**Sydney Metro Northwest Places Program  
Tallawong Station Precinct South  
SSD 9063**

**Submissions Report**

**October 2018**

**Figure 4:** Typical development floor heights (floor to floor) under Concept Proposal showing adherence to ADG requirements for ground and first floors

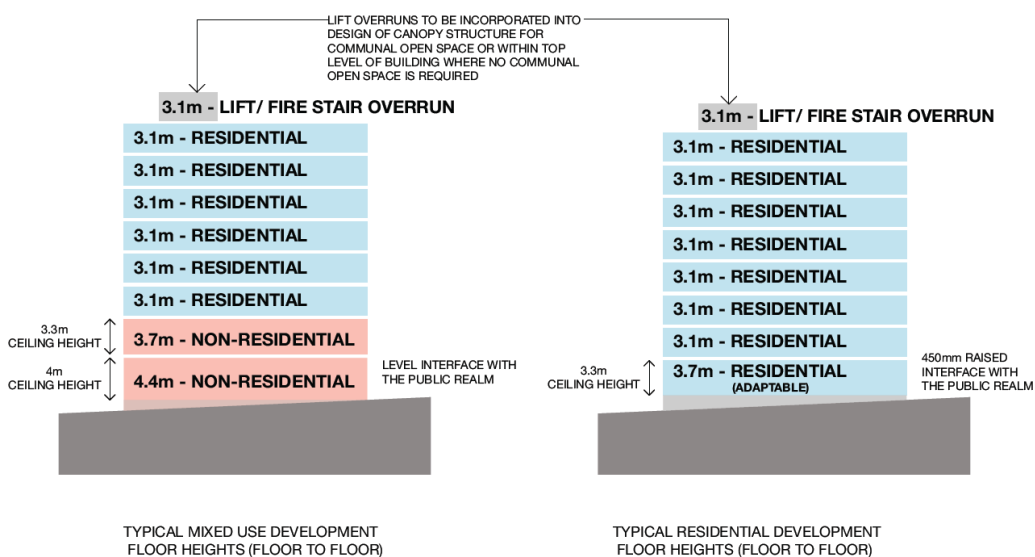
- the proposed quality and quantity of commercial floor space and the implications for building heights and overall strategic planning objectives for the project
- clarification sought regarding floor to floor ceiling heights
- compliance with the Apartment Design Guide.

To accommodate the retail/commercial floorspace, the ground and first floor of buildings in the B4 Mixed Use zone will have higher floor to floor heights than the residential levels above. The floor to floor height of the ground level is proposed at 4.4 metres (allowing for provision of cafes/restaurants) and 3.7 metres on the first floor (floor to ceiling height of 4 metres and 3.3 metres respectively). This accords with the recommendations in the Apartment Design Guide (ADG).

Provision is also made for 3.7 metre floor to floor ceiling heights (floor to ceiling height of 3.3 metre) on the ground floors of building 1B.3 and buildings in the R3 zone to provide for maximum flexibility of ground floor uses in the future, in accordance with the design guidance requirements of the ADG.

The proposed floor to floor heights correspond with the objective in the ADG that the ground and first floor levels of mixed use apartment buildings should have increased ceiling heights to ensure their longer term adaptability for other non-residential uses such as offices and shops. This is shown in Figure 2 and Figure 3 (Figures 4C.1 and 4C.2 of the ADG) on the following page.

The Concept Proposal has adopted the ADG recommendations, as shown in Figure 4.
